REDWOOD LANDFILL FINAL ENVIRONMENTAL IMPACT REPORT

Response to Comments Amendment SCH No. 1991033042

Prepared for: County of Marin March 2008

Figure 1 – Annotated Figure 3-1 from RFSP

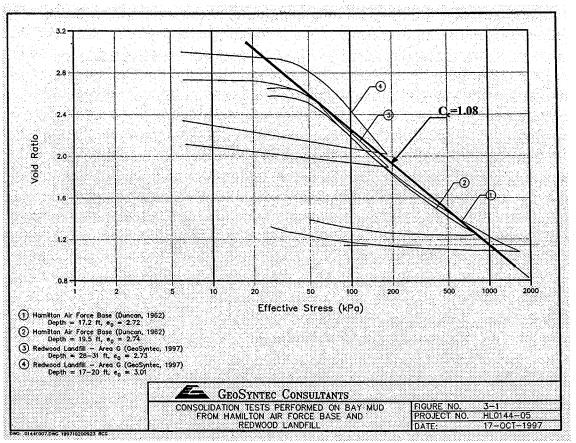
Figure 3-1 from the RFSP (annotated copy attached herein as Figure 1) shows onedimensional compression (e-log p) curves for Bay Mud samples from both the Redwood Landfill and the HAFB. Adding the HAFB curves was necessary to provide coverage over a wider effective stress than that covered by the tests performed on the samples recovered from the Redwood Landfill. In addition to their physical proximity, Figure 3-1 of the RFSP (attached herein as Figure 1) shows that Bay Mud specimens from both sites have essentially the same compressibility, thereby validating the use of the HAFB data. GeoSyntec used the results from the consolidation tests on samples from both the Redwood Landfill and the HAFB to calibrate the Cam-Clay parameters used in the finite element model.

Figure 6 - Measured Field and Laboratory Strengths vs Recommended Strengths

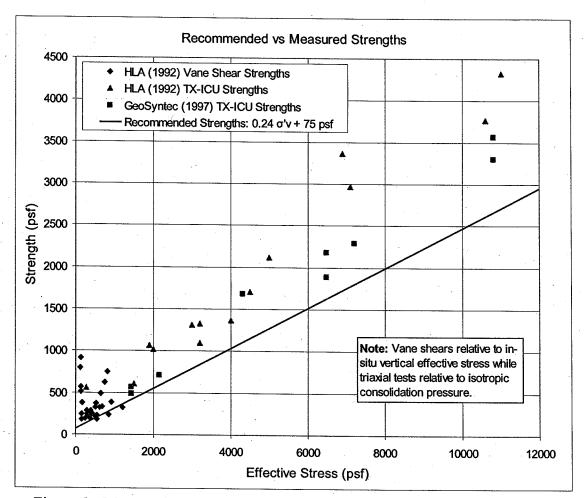
This relationship is shown in Figure 6 superimposed over site-specific corrected field vane shear test results and isotropically consolidated-undrained triaxial strength test results. The figure demonstrates that the above strength relationship forms a conservative representation of the measured strengths. Based on GeoSyntec's experience with Bay Mud at this and other sites, along with the comparison with test data, the strength relationship is appropriate for its intended use.
